CALL NO. 103  
CONTRACT ID NO. 101018  
ADDENDUM # 2

Subject: Jefferson County, IM 0642 (173)  
Letting April 23, 2010

- (1) Revised - Plan Sheets - R2, R2A, R2B, R2C, R2F, R2G, R2J, R2K, R7, R8, R9, R10, R11, R12, R51, & R53
- (2) Revised - Table of Contents - Page 2 of 137
- (3) Added - ITS Notes - Pages 15(a)-15(x) of 137
- (4) Revised - Bid Items - Pages 131-137 of 137

JEFFERSON COUNTY  
TRIMARC RELOCATION ON I-64

COUNTY OF	ITEM NO.	SHEET NO.
JEFFERSON	5-159.10	R2A

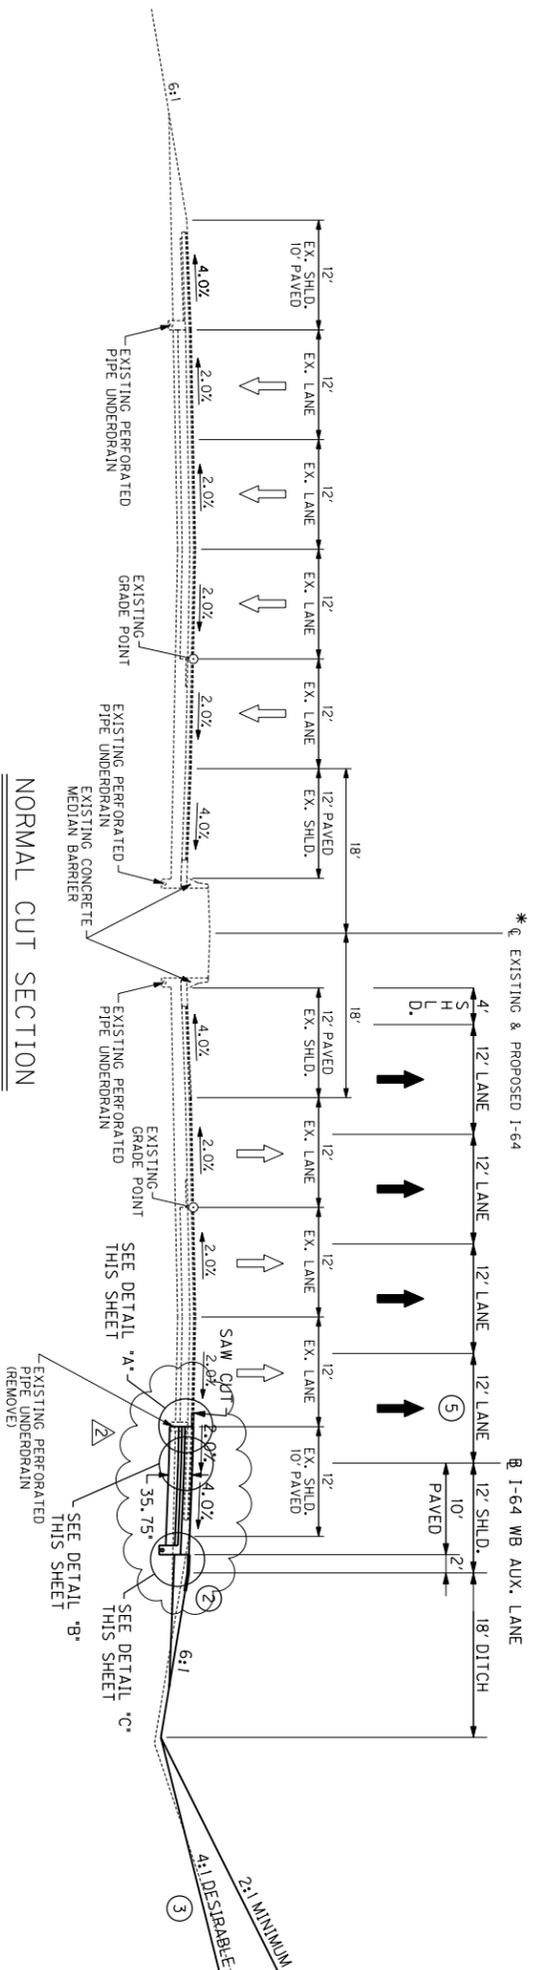
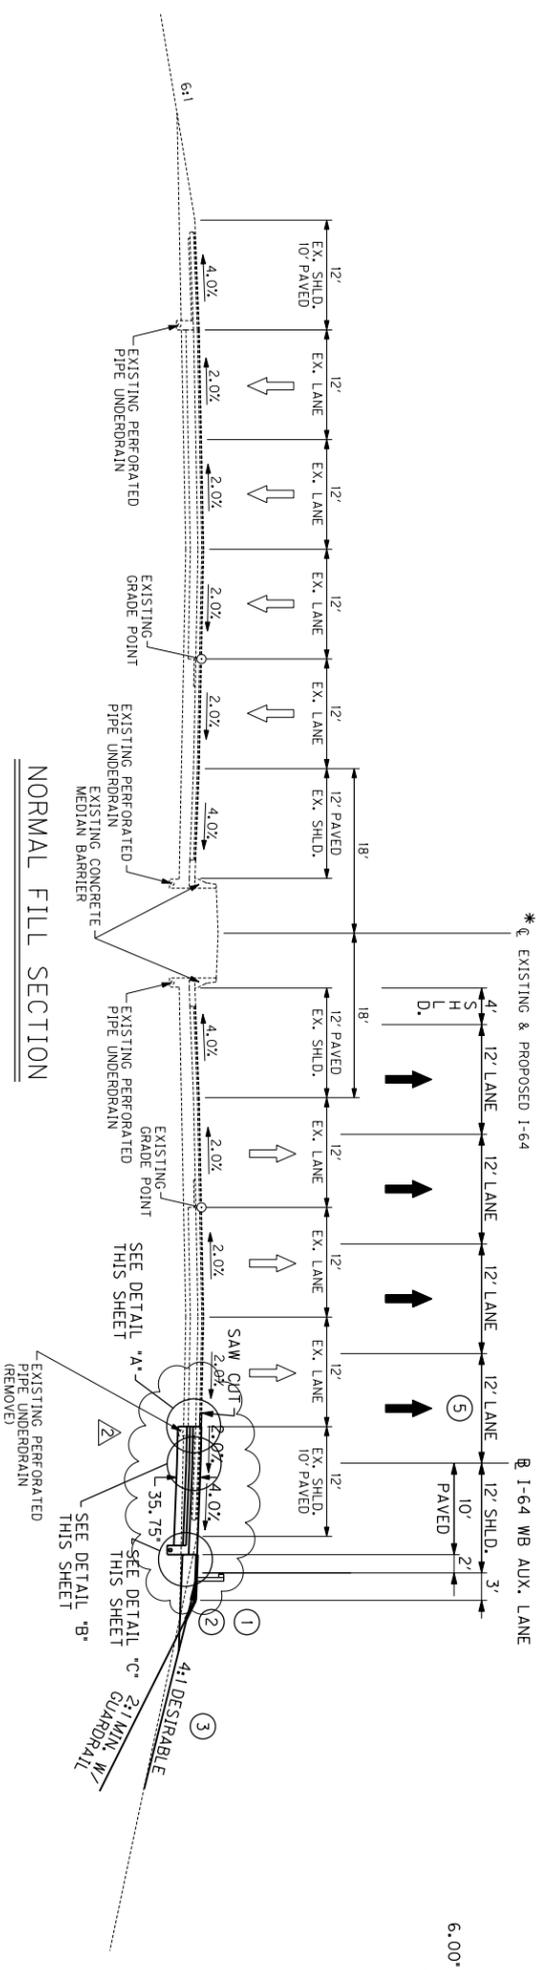
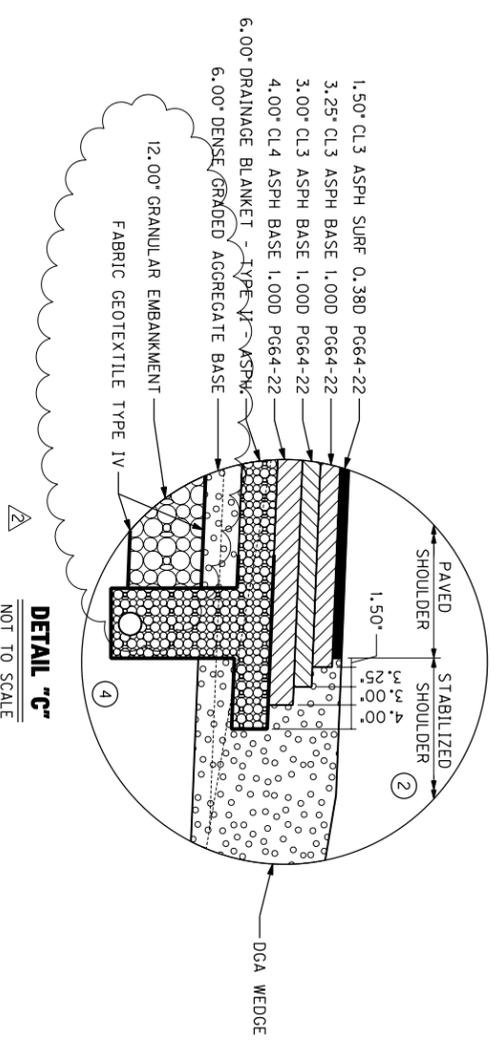
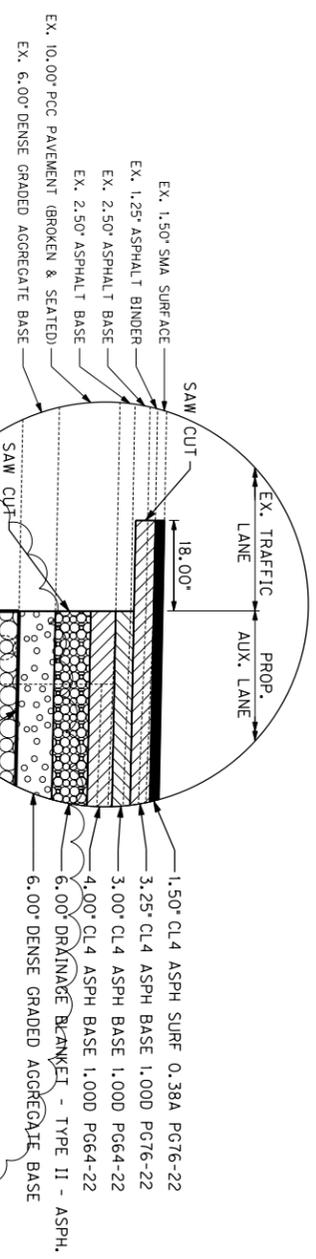
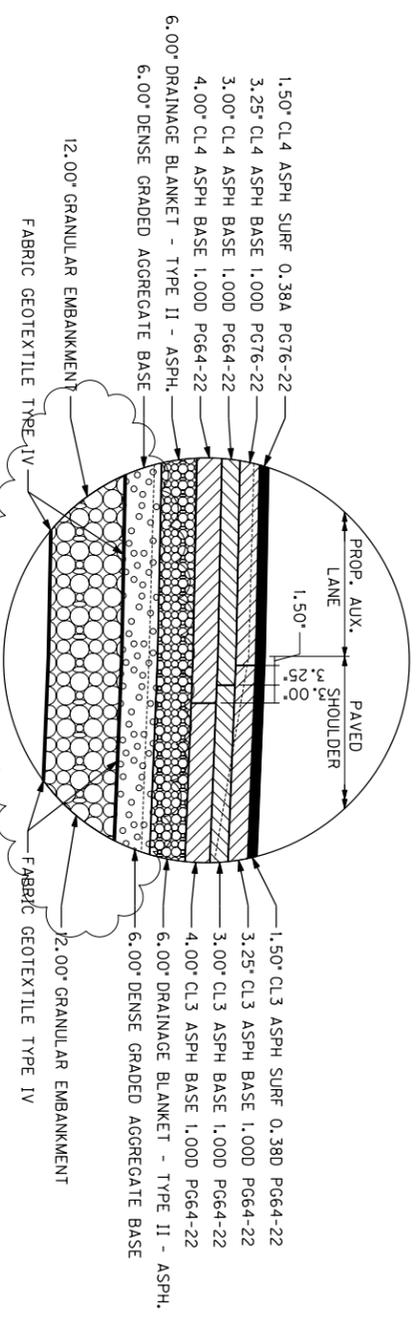
MODIFIED TYPICAL SECTION PAVEMENT DESIGN TO INCLUDE GRANULAR EMBANKMENT
